## **Bid Addendum #1**

### **Pismo Preserve Parking Area, Roadway Improvements, Accessible Trail**

April 23, 2018

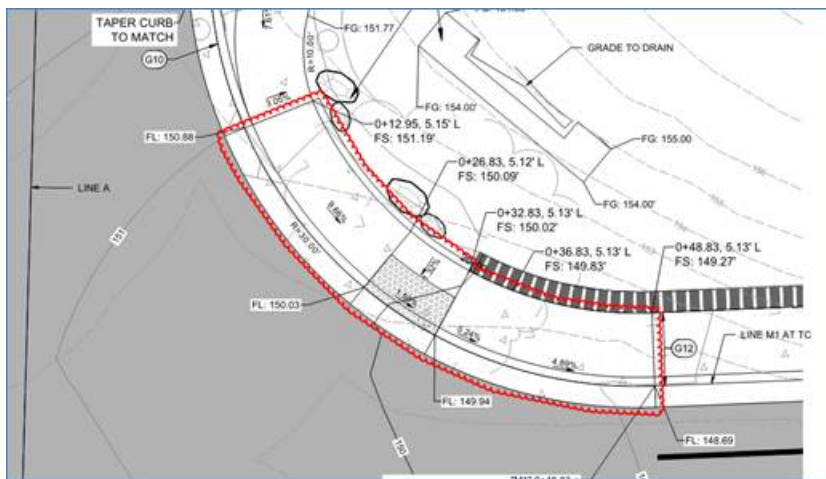
1. Bid Worksheet Item M2-1, HMA Paving – Mattie Road. This item includes the asphalt ramp at the end of sidewalk on Mattie road shown on the plans.
2. Bid Worksheet Item M2-9 Curb Ramp. The 26 SY for this item is the area generally shown below in red.

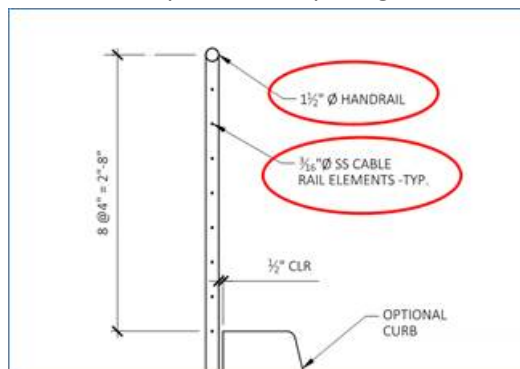
6. Bid Worksheet Item P2-2, Class 2 Aggregate Base - General Parking and Entry Drives includes the 8-inch aggregate base for the equestrian area. Below are the base areas we intended to be included. Base material under concrete is included in the concrete cost.

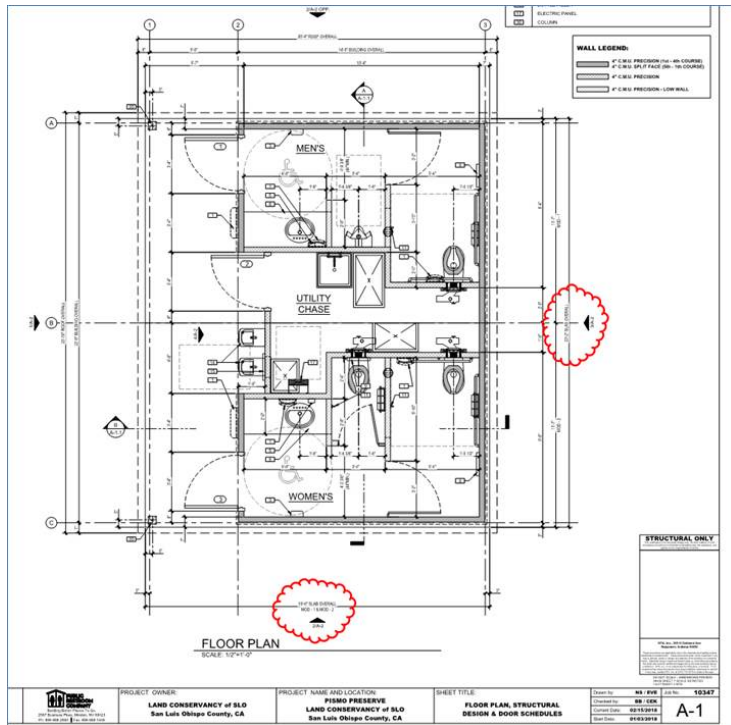
13. Bid Item P9, Restroom
- The Public Restroom Company (PRC) work includes utility extensions within 6-ft of the building. The General Contractor connects the extensions to the water and sewer.

- The restroom will be delivered including a concrete slab that is part of the premanufactured building. The slab limits are included in the restroom drawings, and shown approximately in red below:
